CITY COUNCIL SPECIAL MEETING MINUTES
JULY 11, 2022

CALL-UP BRIEFING: PLANNING COMMISSION APPROVAL OF A DESIGN REVIEW AND EXCEPTION TO STREET RIGHT OF WAY AND IMPROVEMENT REQUIREMENTS ("STREET EXCEPTION") APPLICATION PACKAGE FOR DO IT BEST AT 333 S. WOODLAND AVENUE (DR 22-01 & EXCP 22-03)

SUBJECT: **Annexation of Approximately 39.68 Acres of Territory Known as the Oregon Golf Association Property with no street address along the east side of Boones Ferry Rd NE north of Hazelnut Dr (ANX 22-02) and Approval of Related Land Use Applications for Development into the Marion Pointe Planned Unit Development (PUD)**

To: Planning Commission (June 23, 2022)

Top: Figure 3.01B – Major Arterial (Oregon Hwy 214 / Newberg Hwy)
Bottom: Figure 3.01E – Access Street (Oregon Way)

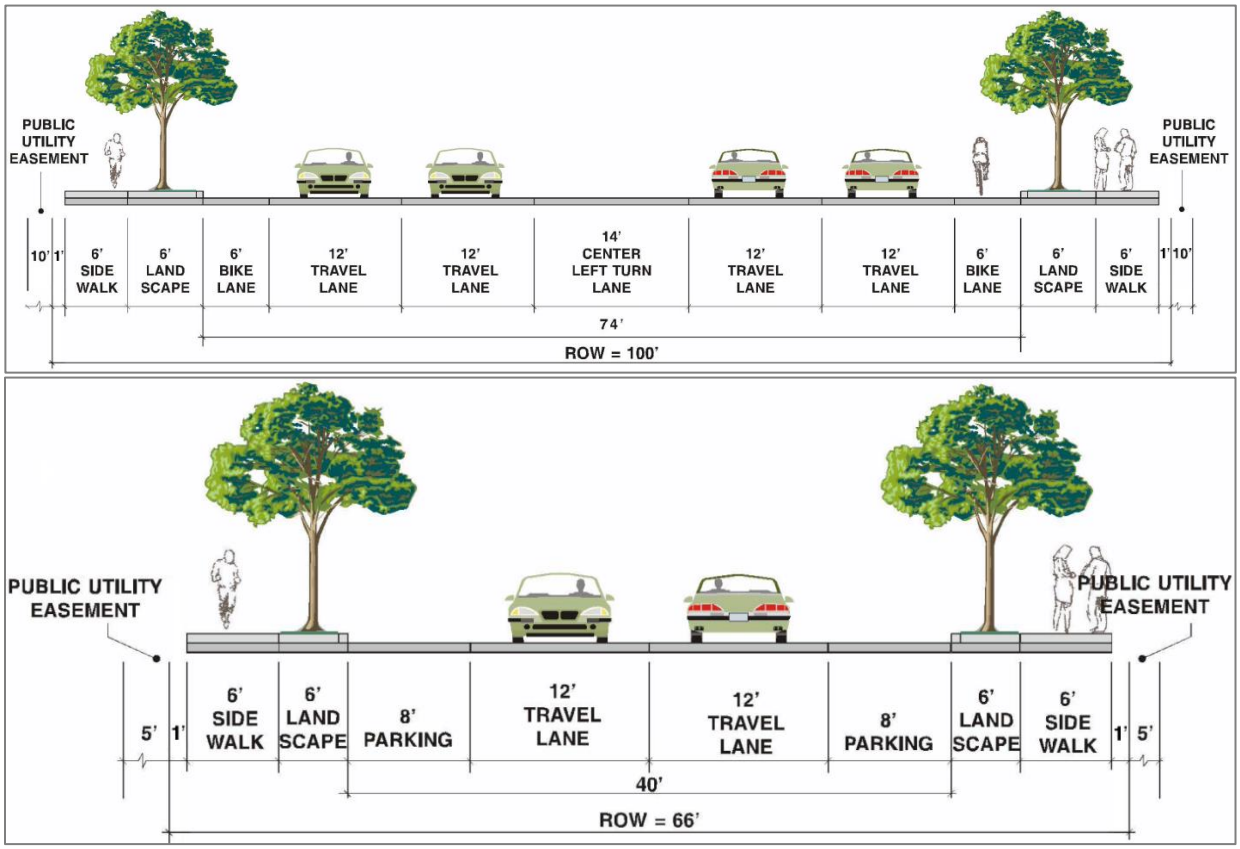
Paragraph 1
Relative to Figure 3.01B, highway non-conformance is limited to lack of planter strip and street trees. Conventional traffic engineering does not address effects of development on walking and cycling as it does for vehicular trips, there is no widely recognized norm for how to address such, and the WDO provides no guidance on the topic. Second, the north frontage context is strip commercial along a heavily trafficked state highway, the kind of dangerous and noisy environment that repels pedestrian and cyclists. Those who do walk and cycle are likely those who are living nearby, the homeless, those without access to car, and those few who wish to brave existing conditions. The presence of a sidewalk is sufficient for sheer practicality for those who wish to walk along a highway or cycle outside of the bicycle lane because they don't feel safe in a highway bicycle lane. In this context, the number of pedestrians and off-street cyclists is moot. Pedestrians and cautious cyclists can and do use the wide sidewalk today, and the pedestrians and cautious cyclists the development might attract would use the same wide sidewalk.

Paragraph 3
Relative to Figure 3.01E, Oregon Way non-conformance is limited to lack of parking lane, planter strip, and street trees. Staff applies conditions that excepts only the parking lane but also requires fee in lieu of such parking. Additionally, the conditions require wider planter strip and wider sidewalk exceeding the minimums of Figure 3.01E. Like conventional development

Exhibit PP1: Option 1 Site Plan Excerpt Prior to Revision per Conditions of Approval

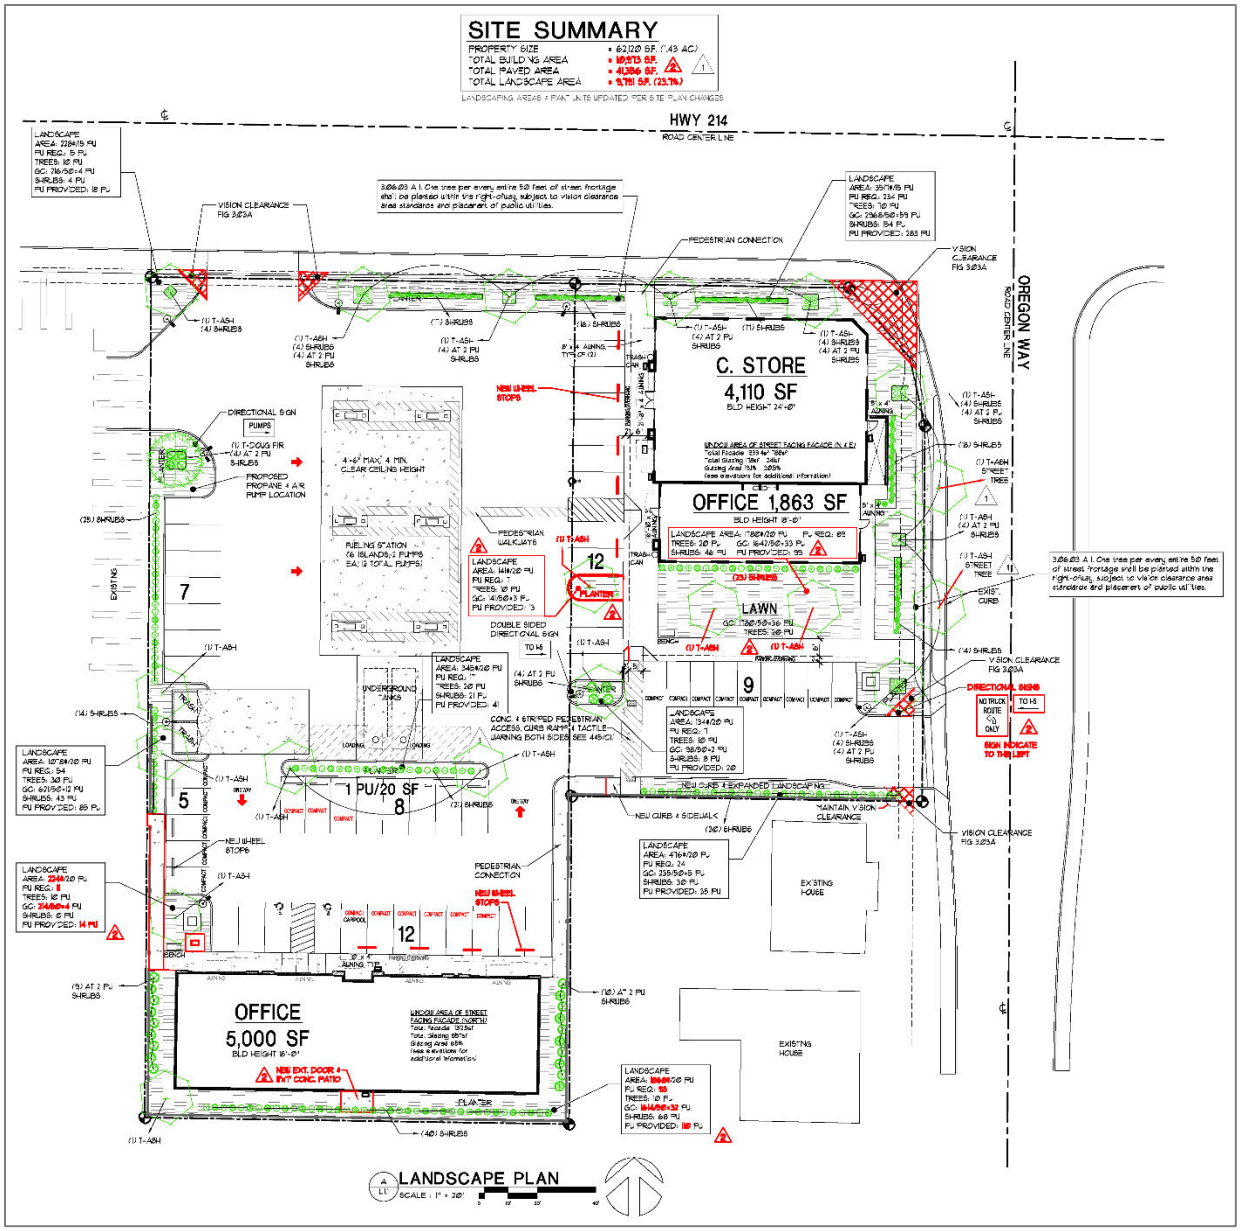
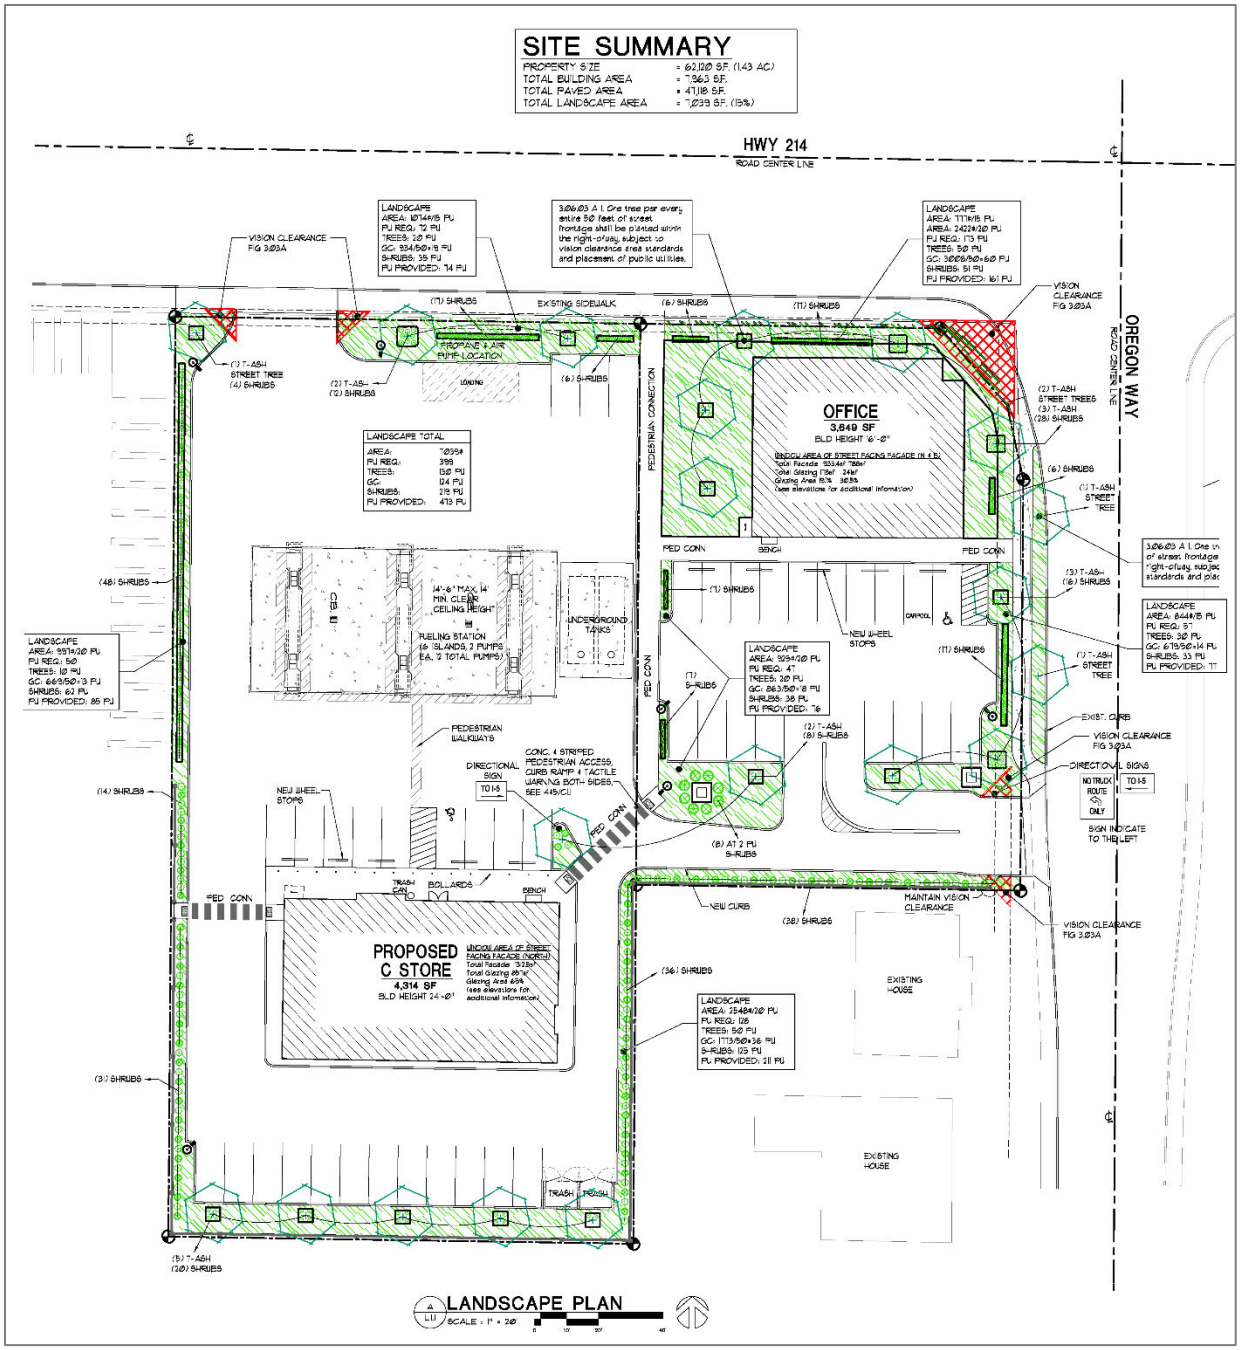
This due by building permit application.
2. Basic Descriptions:
   a. Option 1: See Exhibit PP1 below for plan details.
      (1) On Tax Lot 3600 (east, corner lot), a single northeast building of with convenience store of 4,110 sq ft and a commercial office of 1,863 sq ft.

(2) On Tax Lot 3700 (west, interior lot), a north fuel pump canopy and a south commercial office building of 5,000 sq ft.
   b. Option 2: See Exhibit PP2 below for plan details.

5. By and as part of building permit application, the applicant shall submit revised site plans meeting the conditions of approval.
